ADDENDUM 03

PROJECT: RFP24-012 - Ben Lomond High School Auditorium Remodel

PROJECT NUMBER: 230109

DATE: March 6, 2024

DEMOLITION PLAN - SOUND BOOTH

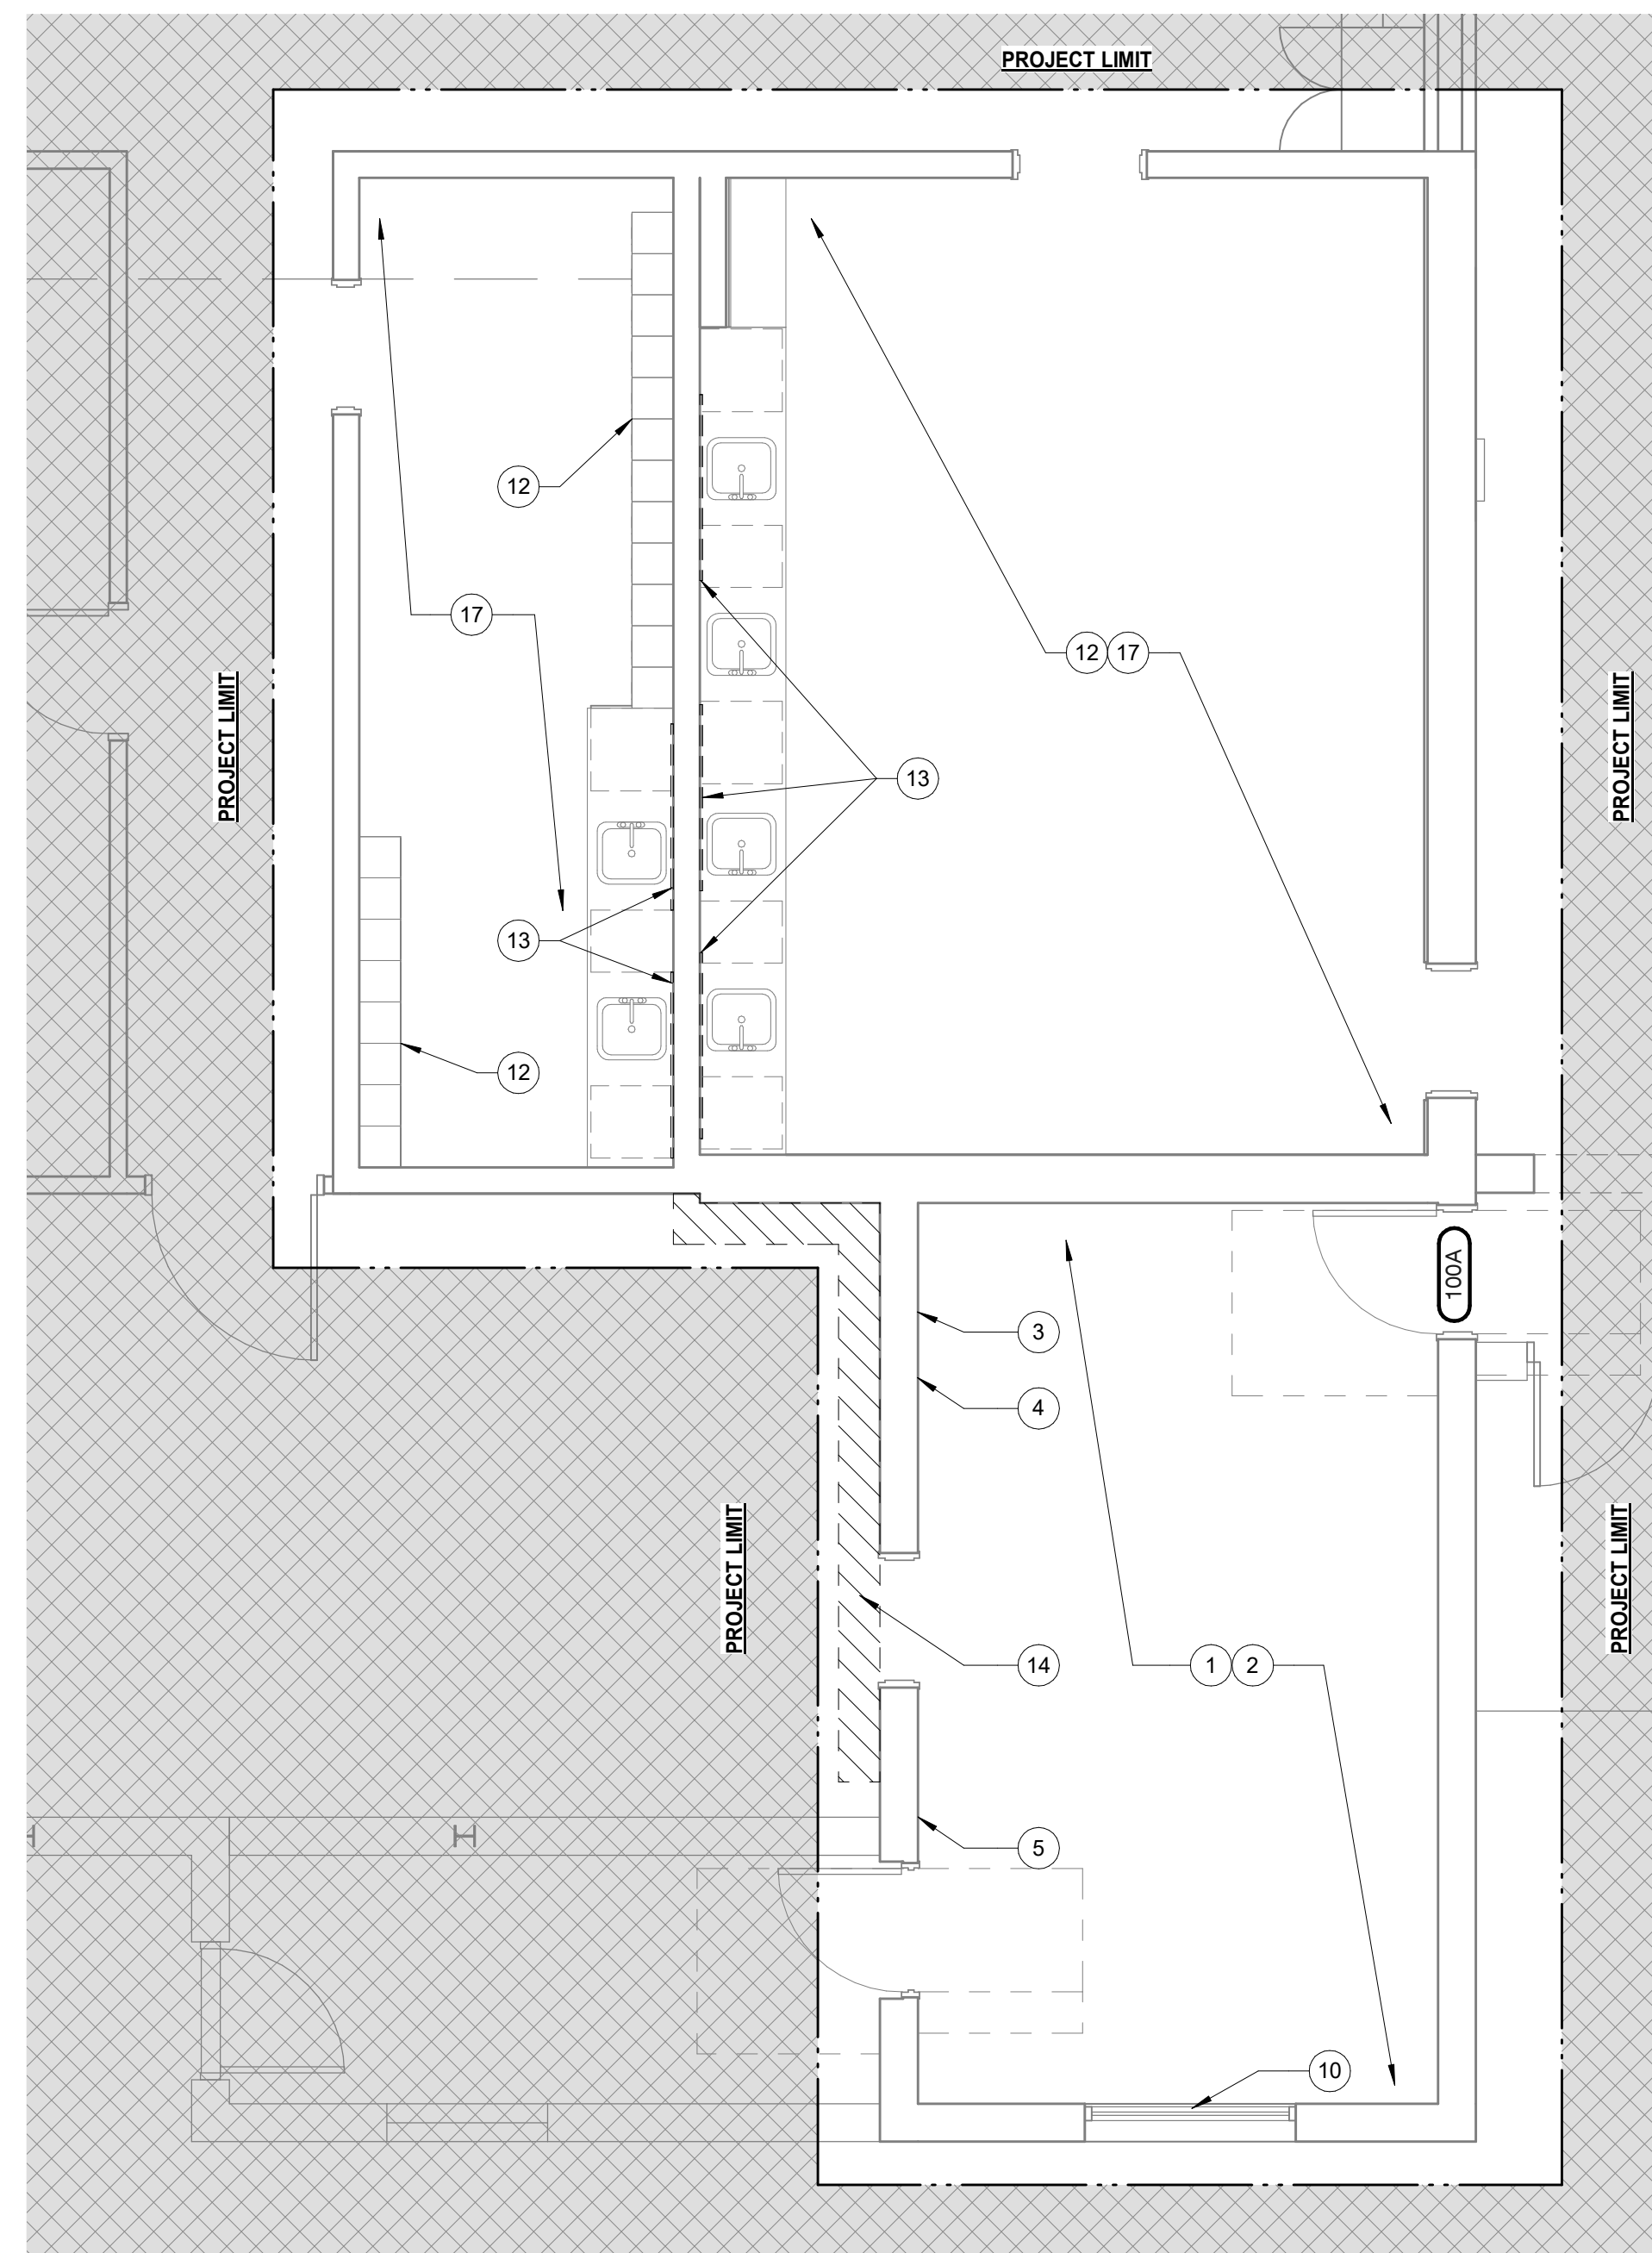
- Keynotes: **Revised** text of keynote #16
- Keynotes: **Added** keynote #18
- Drawing Legend: **Added** symbol and description for existing floor finish to be removed, retained & protected, and reinstalled
- Drawing B 'Demolition Plan – Sound Booth': **Added** hatch pattern to indicate removal, retention & protection, and reinstallation of existing floor finish around ticket booth.
- Drawing B 'Demolition Plan – Sound Booth': **Added** missing keynote tags

FLOOR PLAN - AUDITORIUM

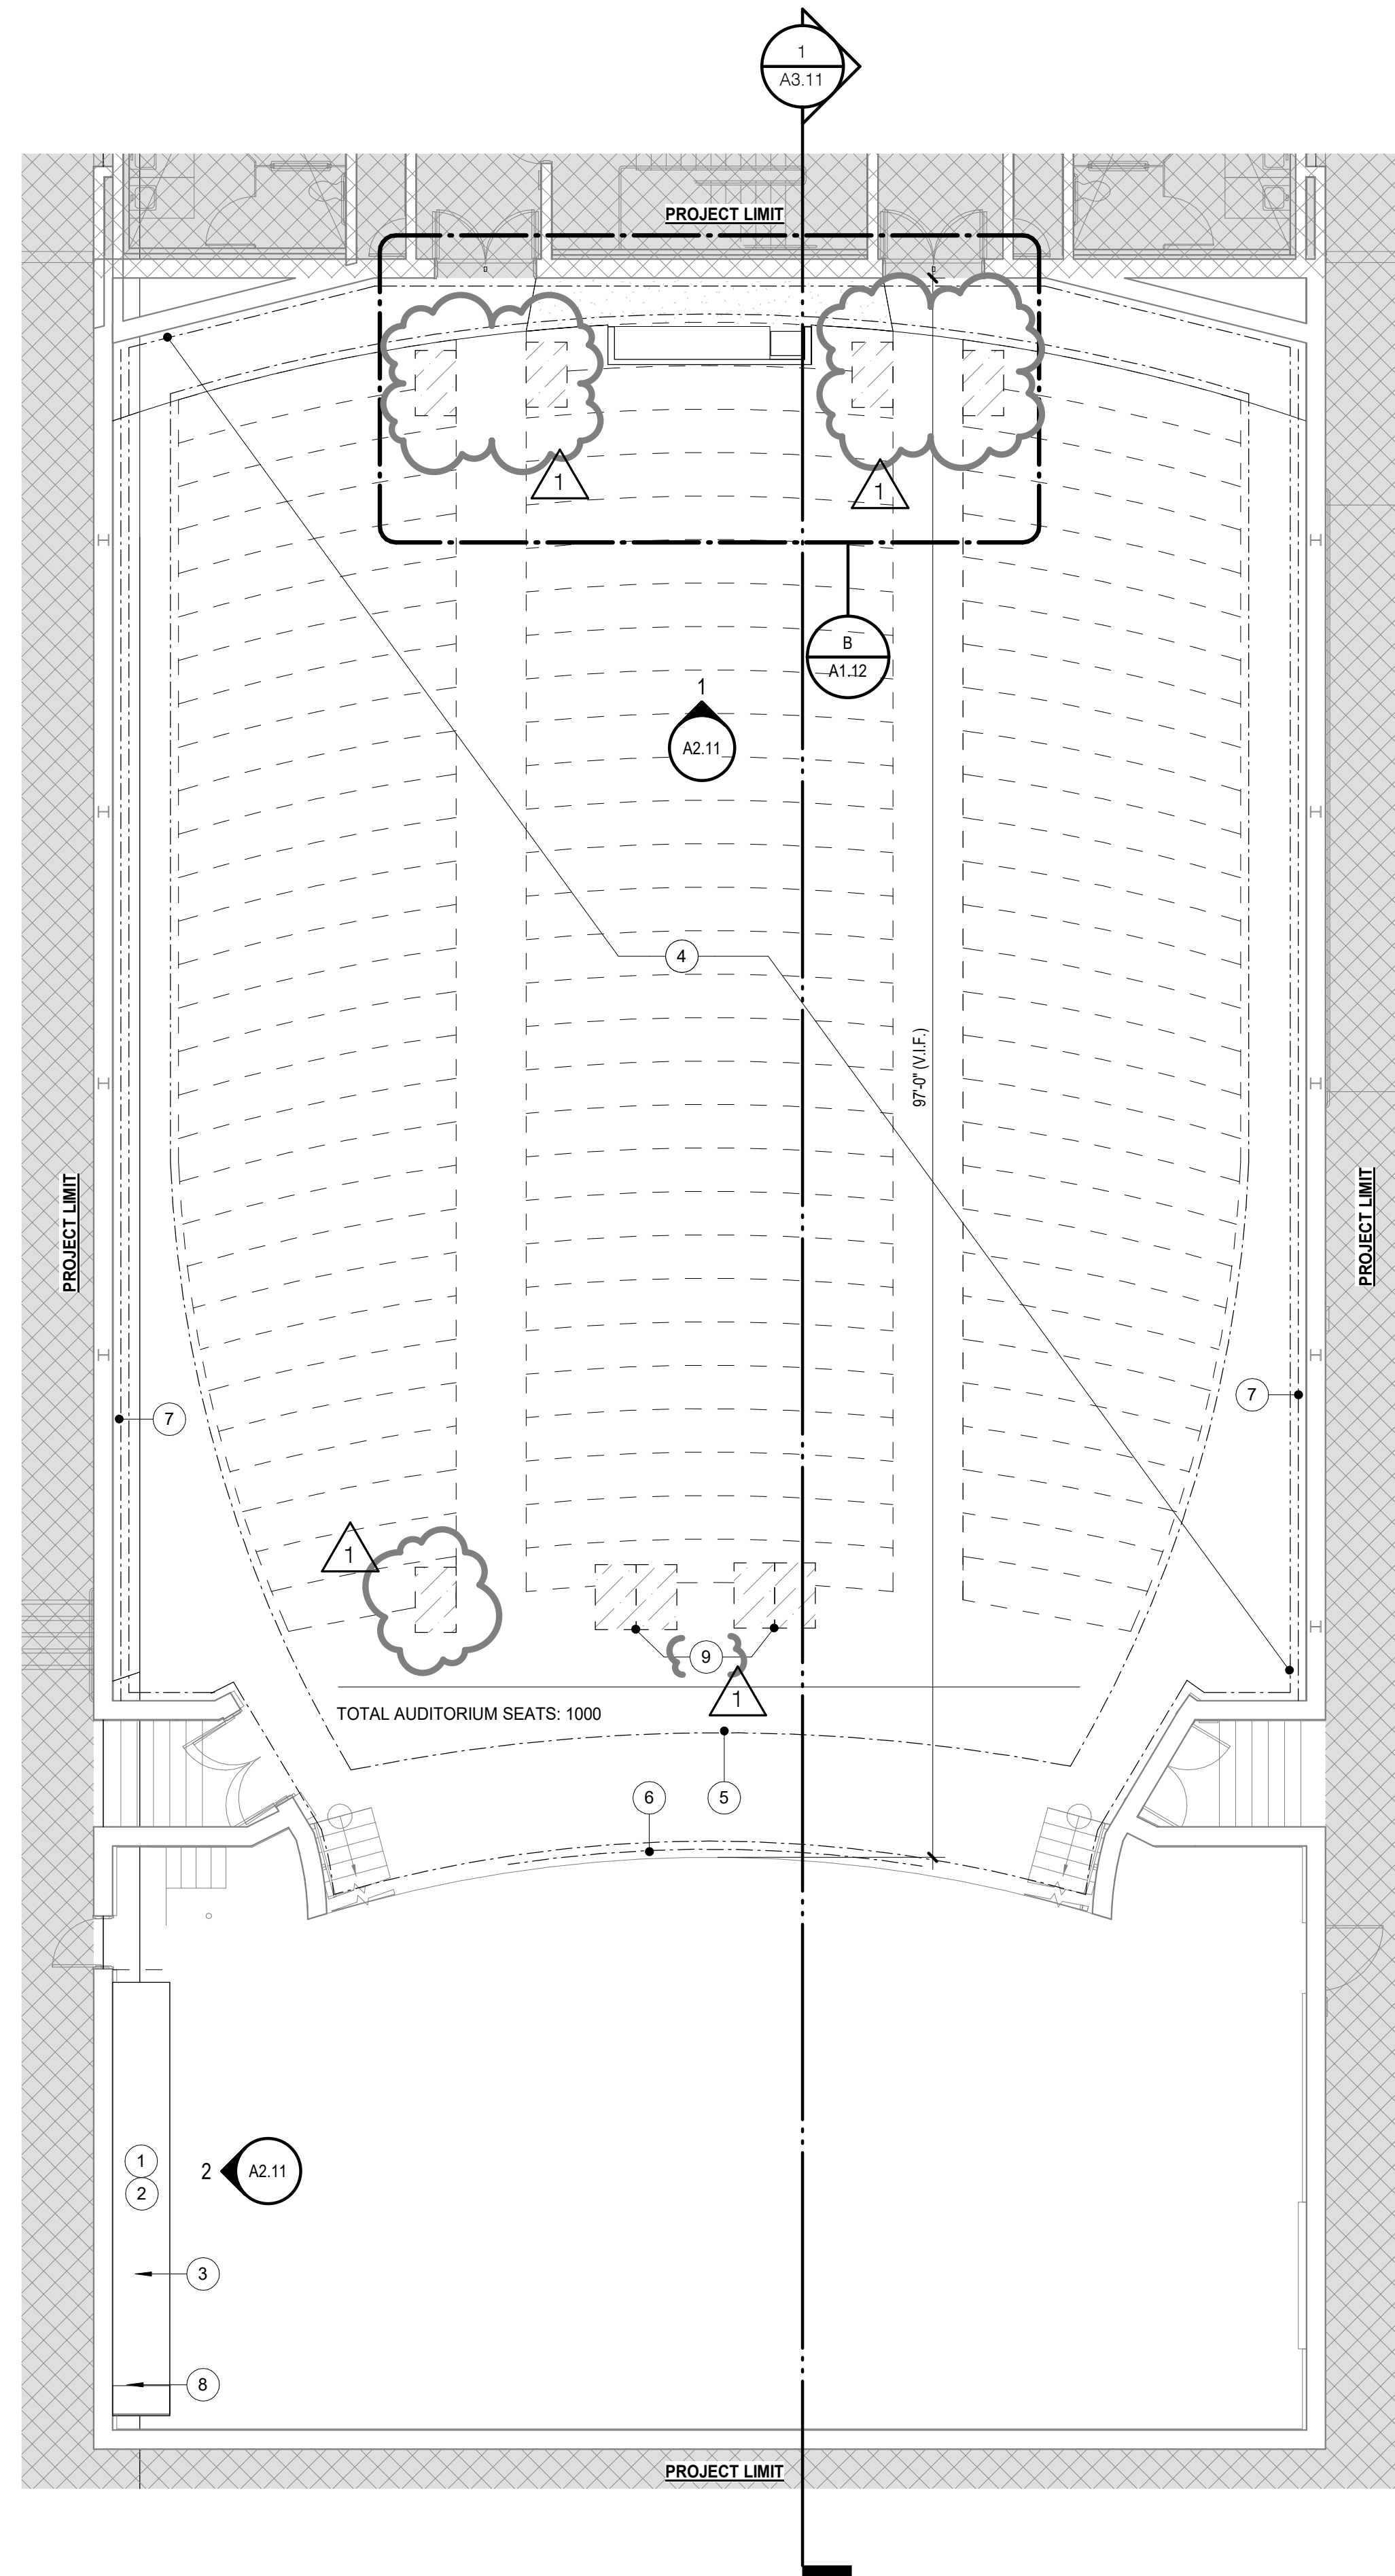
Q11: Sheet A1.11 - There are 4 hashed boxes up front, by the stage. What are these?

Q15: Sheet AD1.1 removes 954 seats. Sheet A1.1 adds 1,000 seats. Where are the extra 46 seat going? It appears to be the same amount of rows, are the new seats smaller?

- Keynotes: **Added** keynote #9
- Add Alt #2 Auditorium Seating: **Revised** narrative to clarify design intent based on bid questions
- Add Alt #4 Auditorium Sidewall: **Revised** narrative to clarify design intent based on bid questions
- Drawing A 'Floor Plan - Auditorium': **Revised** detail number
- Drawing A 'Floor Plan - Auditorium': **Added** keynote #9 to drawings
- Drawing A 'Floor Plan - Auditorium': **Added** ADA accessible and companion seating to drawings

A11: The 4 hashed boxes at the front of the seating are ADA accessible seats. Revised drawings clarifying and updating the quantity and location of the ADA accessible seating will be issued in a future addendum. [Please see revised sheet A1.11]

A14: Confirmed: For add alternate #4, Remove wood wainscotting. Then, for Option 1, provide new framing/drywall buildout to reflect the angles of the walls above, with the new buildout painted to match walls in add alternate #1. And, for option 2, provide new framing/drywall flat to the ground, with new acoustic barrel diffusers installed on the new flat wall.

A15: The quantity of 1,000 seats added are for bidding purposes: contractor will coordinate the final seat count, including attic stock, and final seat locations, including the quantity and location ADA accessible seating and companion seating, with the owner based on existing conditions.
